**Subject: MHI's Response to US-APWR DCD RAI No.321**

**References:** 1) "Request for Additional Information No. 321 Revision 1, SRP Section: 09.05.08 - Emergency Diesel Engine Combustion Air Intake and Exhaust System, Application Section: Tier 2 Section 9.5.8," dated April, 6, 2009

Responses to Request for Additional Information No.321 Revision 1

US-APWR Design Certification  
Mitsubishi Heavy Industries  
Docket No. 52-021

**Figure 9.5.8-1 Gas Turbine Generator Air Intake and Exhaust Component Schematic Diagram**

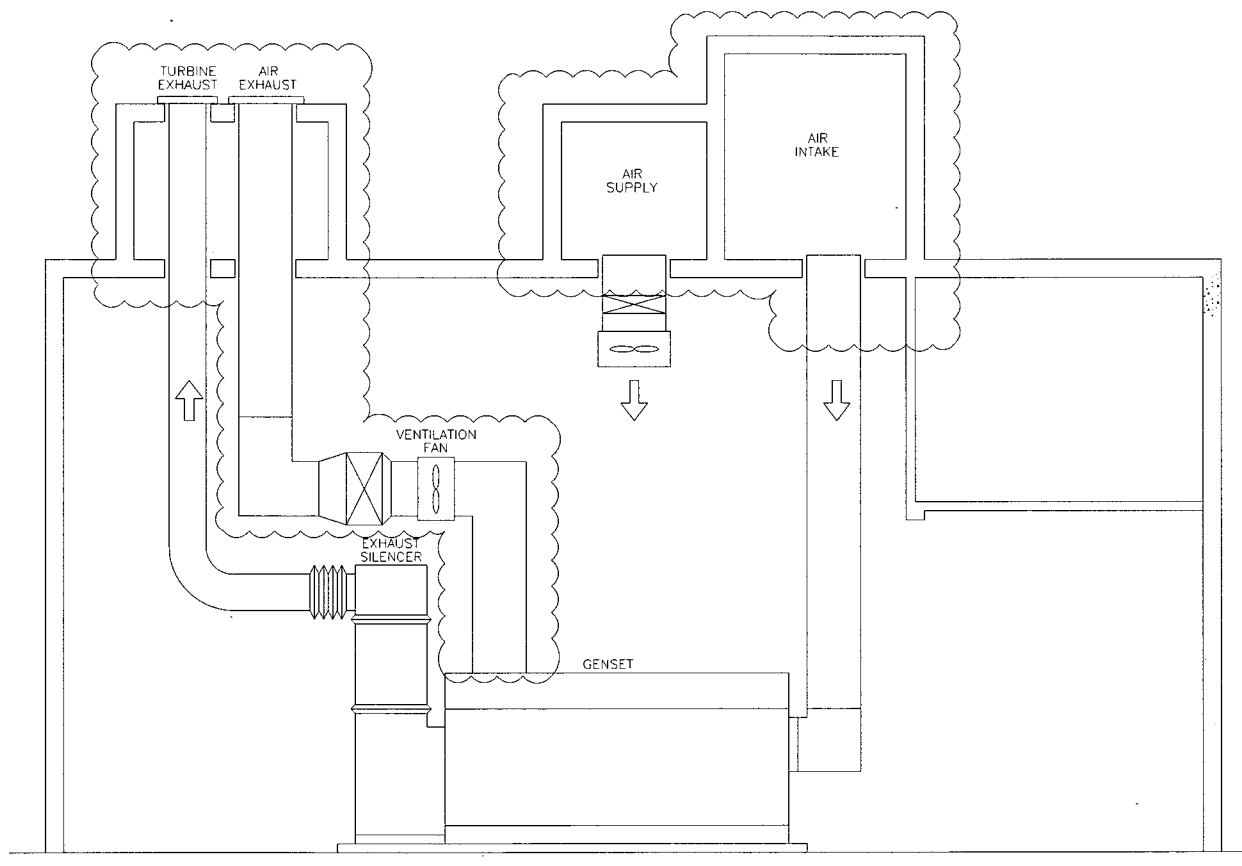
FSAR Tier 2 Section 9.5.8.3.A states that the turbine intake and exhaust openings above the roof of the PS/Bs, and the portion of the piping/ducts above the roof is protected by a guard structure against precipitation and tornado missiles. FSAR Tier 2 Figure 9.5.8-1 shows a roof-top enclosure for one of the intakes, but not for the other air intake or for the GTG or cooling/ventilation air exhausts. In addition, the system description does not provide any specific information about the guard structures. Therefore the applicant should provide details of the guard structure for the GTG exhaust, GTG combustion air intake and ventilation/cooling air intake and exhaust and revise the FSAR to include these design details. In addition, the applicant should verify that the roof-top portions of the GTGCAIES are all designed in accordance with GDC 2.

The staff requires information regarding potential damage to the GTGCAIES from naturally occurring or plant accident generated missiles for portions of the system that are not contained within a reinforced concrete, seismic Category I, missile-protected, flood-protected structure. The applicant should identify portions of the system that are not contained within this type of structure and describe how they will be protected to meet GDC 4 and revise the FSAR to include these design details.

The GTG combustion air intake and exhaust gas openings and the cooling/ventilation intake and exhaust openings on the roof of the PS/Bs and the portion of the piping/ducts above the roof are all protected by guard structures. DCD Tier 2 Figure 9.5.8-1 is a schematic diagram.

DCD section 9.5.8.3.A will be updated to include additional description of the guard structures. DCD Tier 2 Figure 9.5.8-1 title will be updated in DCD Revision 2 to indicate that the drawing is a schematic representation and not a physical drawing that depicts the gas turbine generator air intake and exhaust gas components.

- DCD Tier 2 Figure 9.5.8-1 title will be revised as follows to indicate that the drawing is a schematic representation:

**“Figure 9.5.8-1 Gas Turbine Generator Air Intake and Exhaust Component Schematic Diagram”**

- DCD Tier 2 Figures 9.5.8-1 will be revised to show the guard structure openings for the GTG intake and exhaust openings and room cooling / ventilation air intake and exhaust schematically as shown in Attachment B.
